**DATE:** 09.26.2018

**FROM:** Mitesh Baxi  
Traffic Engineering

■ **SALVATION ARMY CORPS COMMUNITY CENTER & CENTER OF HOPE [Subdivision Plan Review]**

☞ Initial Review Note ☞

# Salvation Army Corps Community Center & Center of Hope Standard Street Lighting Plan

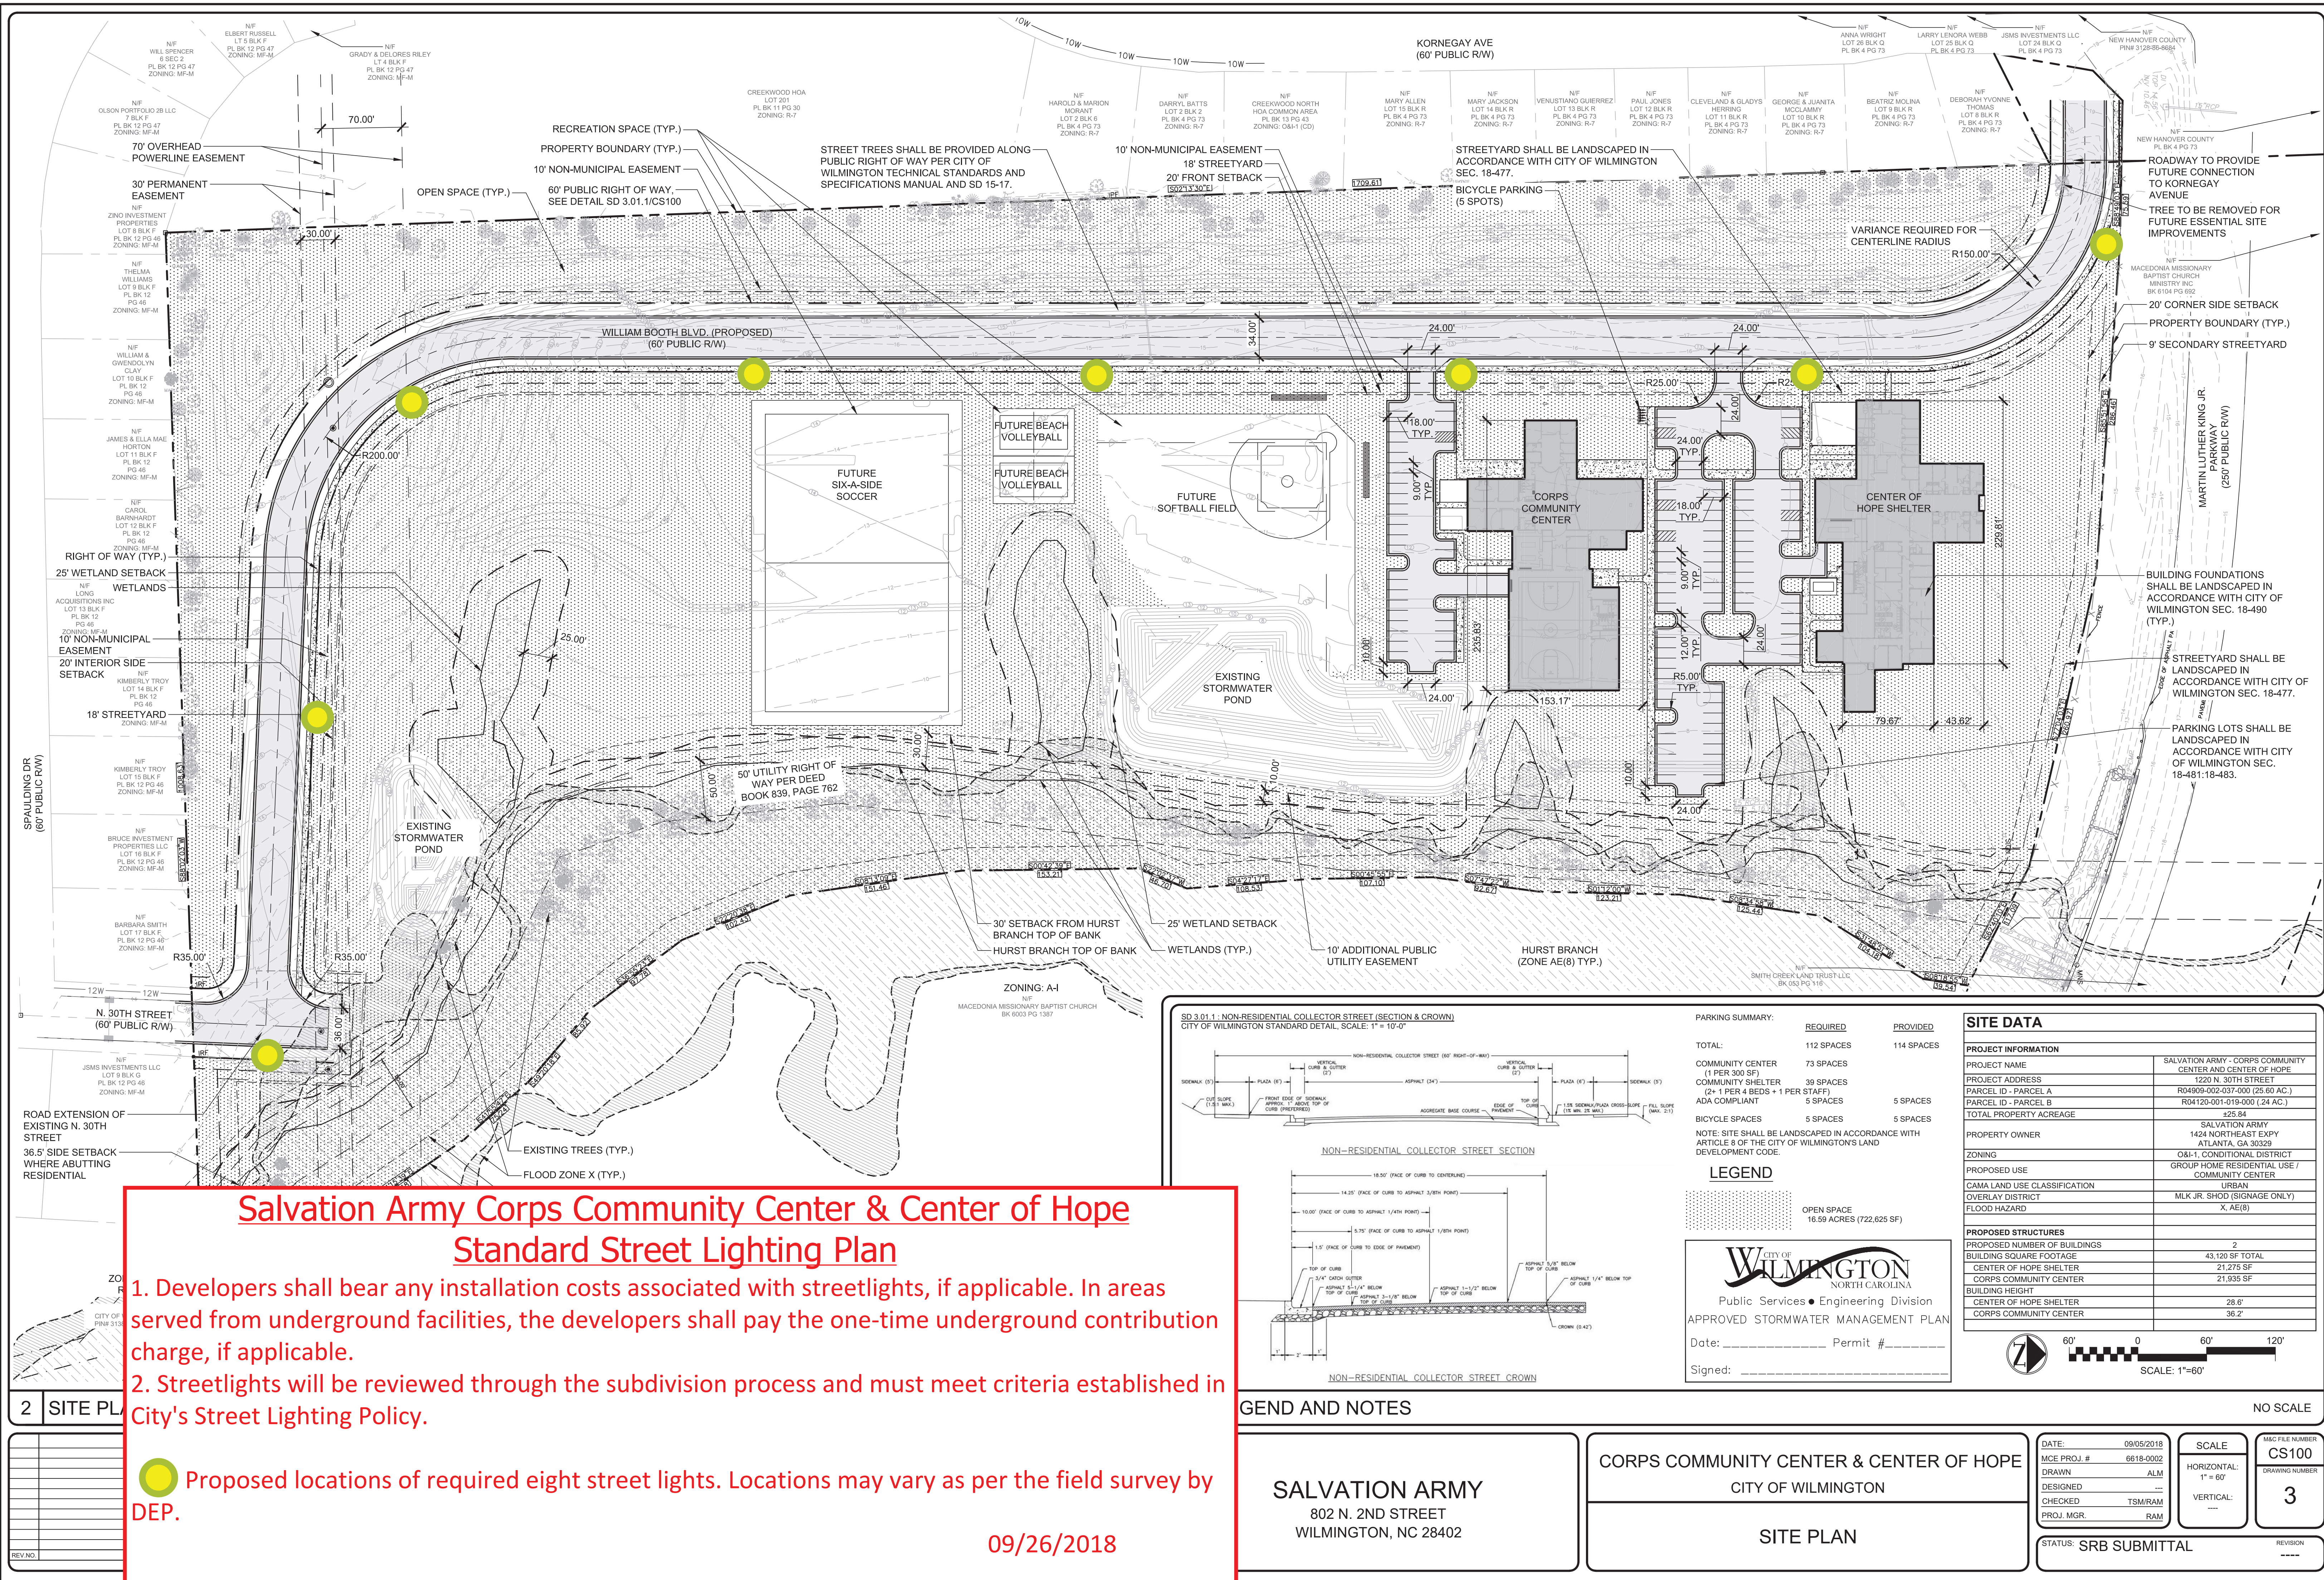
2. A layout for the Standard street lighting has been provided with the review. Minimum of 8 (eight) street lights are required for this sub-division. Although, developers may choose to provide any extra lights or ornamental. Any installations above the criteria of Standard street lighting, will be considered as non-standard and has to conform to the City's non-standard street lighting procedure as per the policy.

Proposed locations of required eight street lights. Locations may vary as per the field survey by DEP.

SITE PLAN

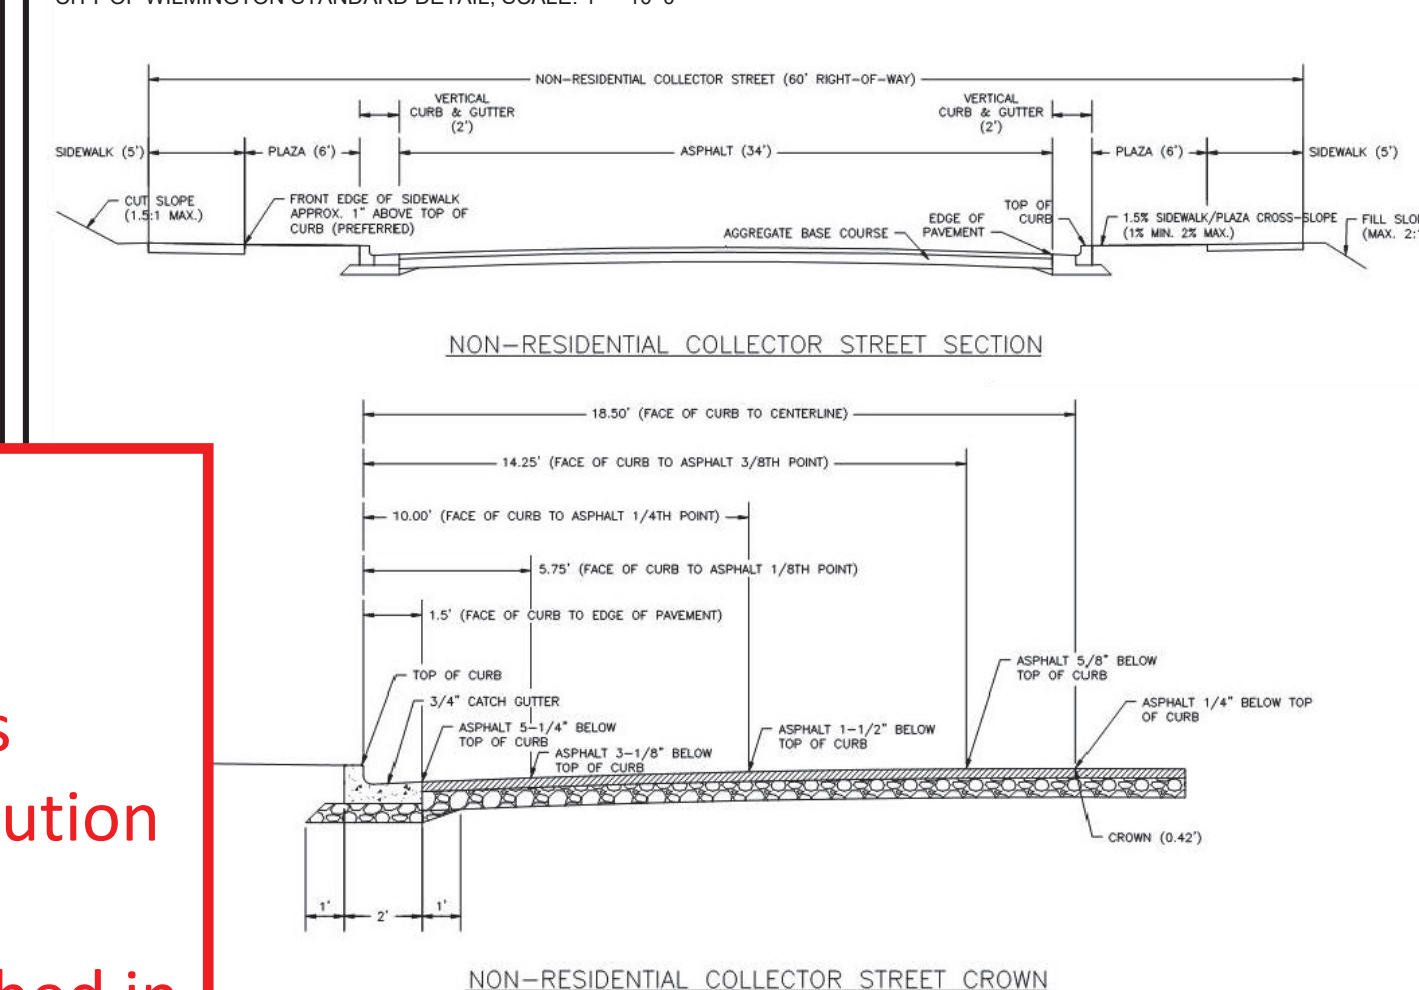
1. The intersections of N 30<sup>th</sup> St/Spaulding Dr and N 30<sup>th</sup> St/Proposed William Booth Blv are closer than the 400' minimum distance per the City's technical standards. [7-5 CofW Tech Stds]. A variance may be required.
2. Show a cross-section detail showing the existing street and the proposed widening.
3. Show a vertical profile for each of the proposed streets.
4. Install wheelchair ramp at corner of N 30<sup>th</sup> St and Proposed William Booth Blv per NCDOT and/or City standards. Connect sidewalk with ramp.

5. 'Stop' sign and stop bar shall be installed at the intersection of N 30<sup>th</sup> St and William Booth Blv for William Booth Blv vehicular traffic. [MUTCD]
6. Site plan indicates that proposed ROW William Booth Blv will not be connected to the Kornegay Ave and will be terminated for future connection. In these circumstances 'End of roadway' markers at the northern end of street, 'No outlet' signage at the intersection of N 30<sup>th</sup> St and Proposed William Booth Blv [MUTCD] and a turnaround shall be required at the northern end of proposed ROW.

7. Show appropriate City standard detail(s) on plan. [SD 3-03.3 & 3-03.4 CofWTSSM]
8. Dimension driveway tapers widths. [Sec.18-530 CofW LDC]
9. Provide dimension for the width of plaza.
10. Provide dimension for the width of sidewalk.
11. Provide sidewalk detail SD 3-10 on the plan.
12. Provide curbing detail SD 3-11 on the plan.
13. Show and apply the City's 20'x70' sight distance triangle at each driveway and the City's 46'x46' sight distance triangle at each street corner intersection on the site plan and landscaping plan. [Sec.18-529(c)(3)CofW LDC] Add a note indicating that all proposed vegetation within sight triangles shall not interfere with clear visual sight lines from 30"-10'. [Sec.18-556 CofW LDC]

14. Dimension parking radii. [Sec. 18-529(b)(2) CofW LDC]
15. The minimum radius is 25' for any portion of a parking lot adjacent to a travel way (i.e. islands at the end of a parking bay) for parking that is open to the public. If the travel way will not be used for emergency service vehicles or truck traffic, you may request a tighter radius, the minimum is 15'. This request must be made in writing (an email message is acceptable). [Chapter VII, Detail SD 15-13 CofWTSSM]
16. Please show all the traffic control devices and pavement marking showing the traffic flow for this project.
17. Provide a turning movement analysis of an emergency vehicle for this development.
18. Handicap ramps shall be installed at the end of sidewalks within parking facility.
19. Appropriate pavement markings/signage will be required wherever pavement is approaching the entrance of the building facility.

20. Parking summary indicates ADA compliant spaces but site plan is missing the location details.
21. International symbol of Accessibility parking space marking is required as per fig. 3B-22 of MUTCD.
22. Please show location of accessible ramp(s) and parking signs and provide details on the plan.
23. Show the typical handicap sign detail on the plan as per ADA and City standards. [Sheets A1 of 5 and A2 of 5, CofW Sign Specification]  
<https://www.wilmingtonnc.gov/home/showdocument?id=3940>

24. Sidewalk as proposed where adjacent to 90 degree parking spaces shall meet ADA requirements. An allowance for a 2.5' vehicle overhang must be considered. 4' of the sidewalk must remain clear for pedestrian use. [\[Chapter VII, Detail SD 15-13 CofWTSSM\]](#)
25. Note/label the plan with spot elevations that clearly indicate the accessible route from the HC space(s) to the building. [\[Sec. 18-529\(b\)\(2\) CofW LDC\]](#)
